## IMPORTANT SAFETY NOTICE

### Rolf Prima Free Hub Body Replacement Instructions

fig. 1

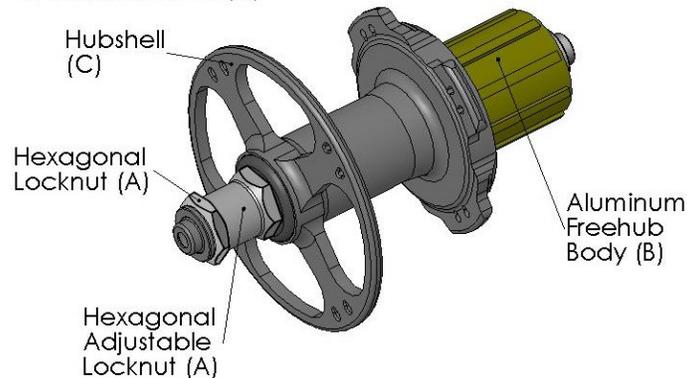
Some Rolf Prima Vigor and Élan model rear wheels sold in 2003 are affected by this safety notice. These wheels can be easily identified by three tell-tale characteristics of the rear hub: [see fig. 1]

- First, there are hexagonal axle nuts at the left side of the rear hub.
- Second, the free hub body is aluminum, with a gray-green color anodized finish.
- Lastly, only black hubs are affected. Silver hubs are not subject affected.

Affected hubs have:  
1. Hexagonal nuts on left (non-drive) side (A)  
2. Aluminum Freehub body (B)  
3. Black hubshell (C)
